November 20, 2002

The Drawing Objections

Fig. 1

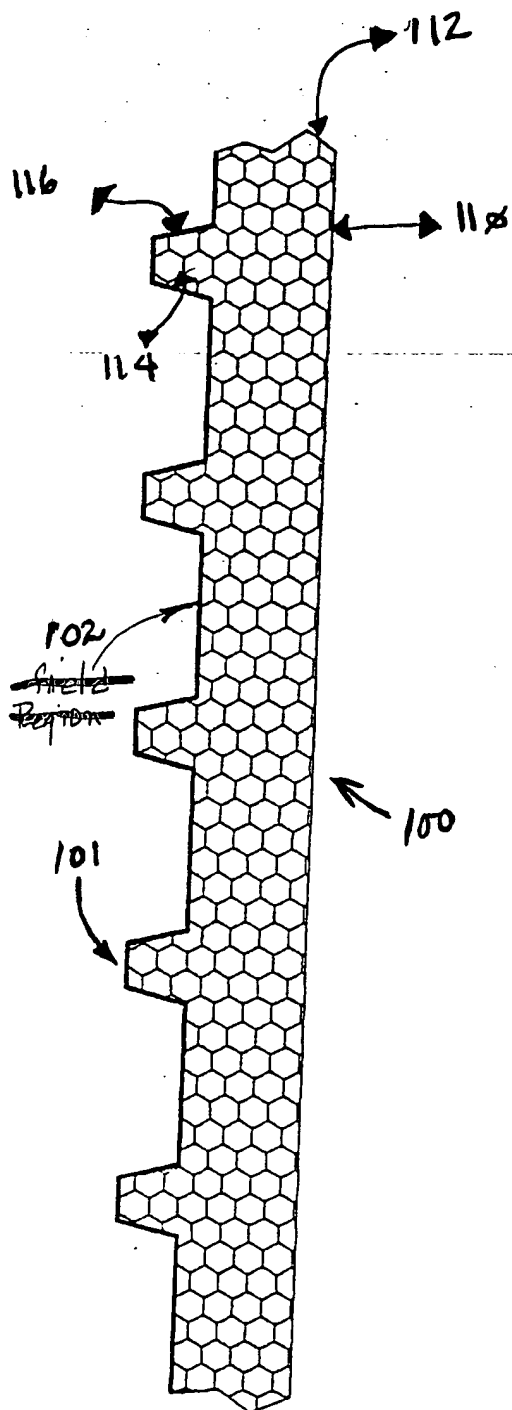
The drawings stand objected to because examiner states that they fail to show ramlocks and grommets as described in the specification, because Figure 1 contains text, and because all component numbers are faded.

Figure 1 has been amended to remove the text.

Fig. 3

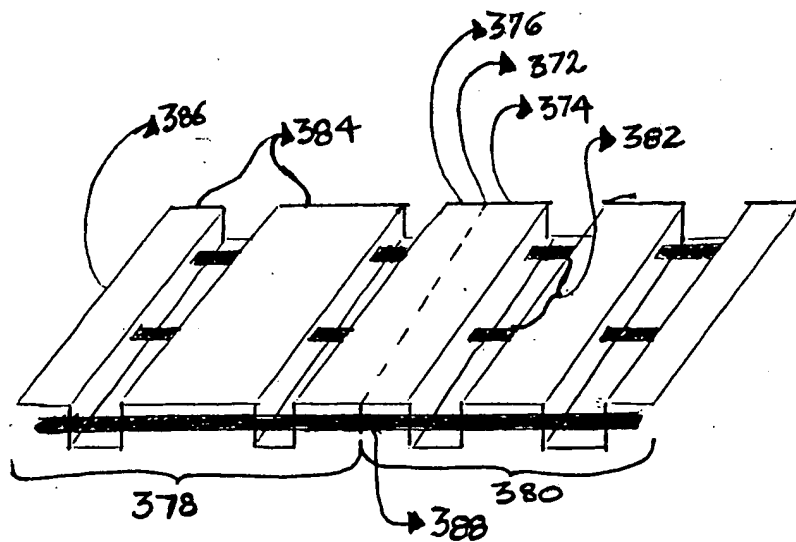
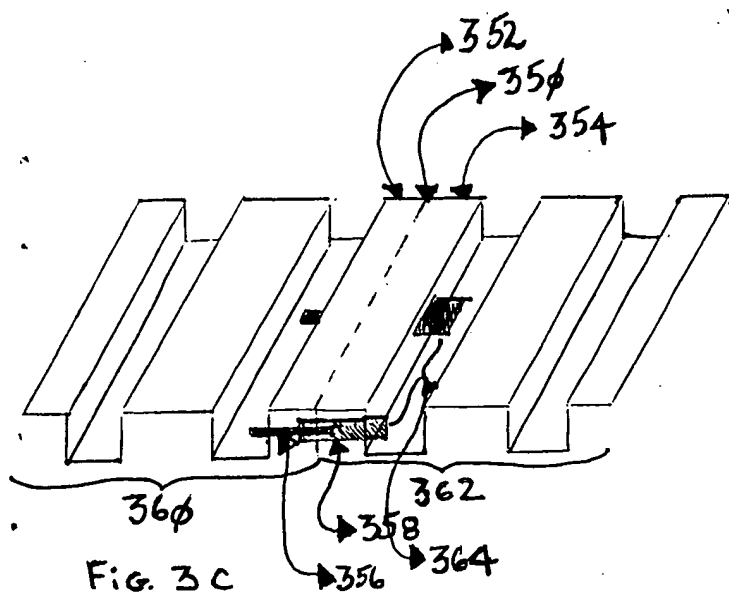
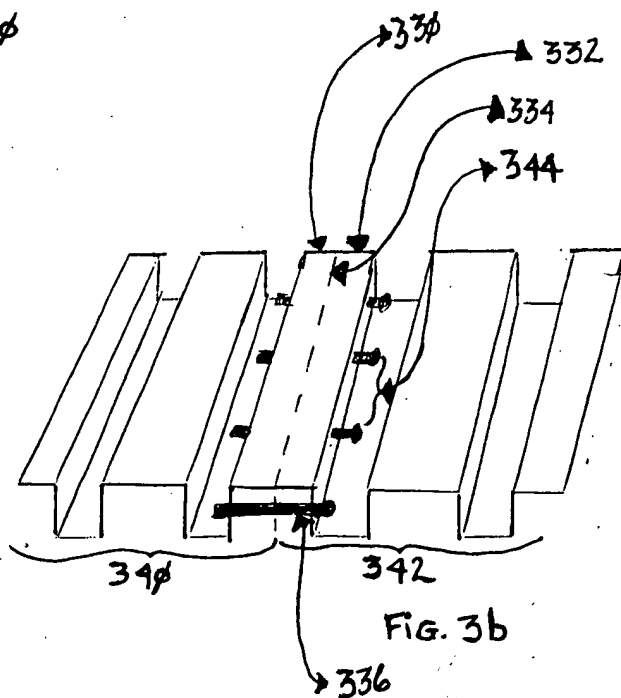
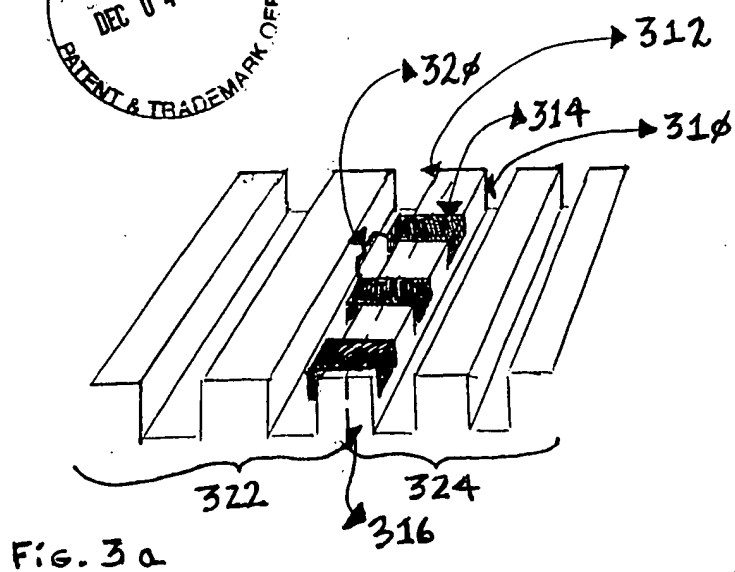
Examiner contends that Figures 3b-3d do not show the ramlocks and grommets or any means of how they are used to connect the panels. Applicant is somewhat confused and respectfully traverses this objection. Figure 3b clearly shows several ramlocks, as element number 336. Ramlocks 336 are shown clearly inserted through the material of the panel at ribs where two panel edges abut. Thus, ramlocks 336 are clearly shown, and are shown in place holding two panels together. Similarly, Figure 3c clearly shows grommets 356/358 in place, holding two panels together. As with ramlocks 336, grommets 356/358 are inserted through the material of the panel at ribs where two panel edges abut. See Page 8 of the specification for an explanation of Figures 3b and 3c. In addition, as noted on Page 8 of the specification, ramlocks and grommets are articles whose general structure and function are known in the art and thus great detail is not required in text or drawing to show their means of action.

Therefore, because ramlocks 336 and grommets 356/358 are clearly shown in Figures 3b and 3c respectively, and are clearly shown in action/position holding panels together in Figures 3b and 3c respectively, Applicant has not made any changes to these figures and respectfully requests that Examiner withdraw this objection. Applicant welcomes a call from Examiner to clarify any outstanding issues with respect to the drawings, or to have Examiner further explain what about the ramlocks and grommets he believes need clarification.
